**APPENDIX H**  
**COMMUNICATION RECORDS**  
**FOR DESIGN CHANGES**

## DESIGN CHANGE 1 AND 2 CORRESPONDENCE

| Project METAL BANK  | Subject FILLET WELD BTWN. MC & HP CHECK | By JJC         |

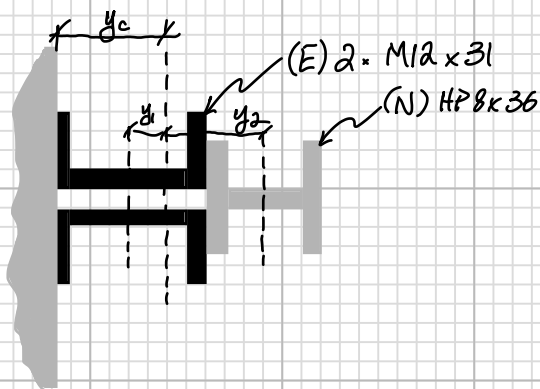
- He questioned the need for full welding along the entire length (top and bottom) of the support brackets. The design drawings call for it, so I assume that is what we will be doing, but he said it is time-consuming and may not be entirely necessary. He's checking with one of his technical guys about this now (what

length of weld is actually needed to support the forces applied by the wall). WE TOOK A SECOND LOOK AT THE CONTINUOUS WELD, THEY CAN WELD 2" EVERY 6". SEE ATTACHED CALCULATIONS.

PER AISC J2.4, MIN. WELD =  $3/16" \rightarrow 5/16"$  SPECIFIED

$$MIN \% \text{ CONTINUOUS WELD} = \frac{1.5}{9.28}(100) = 16\%$$

2" WELDS TOP & BOTTOM @ 6" O.C.
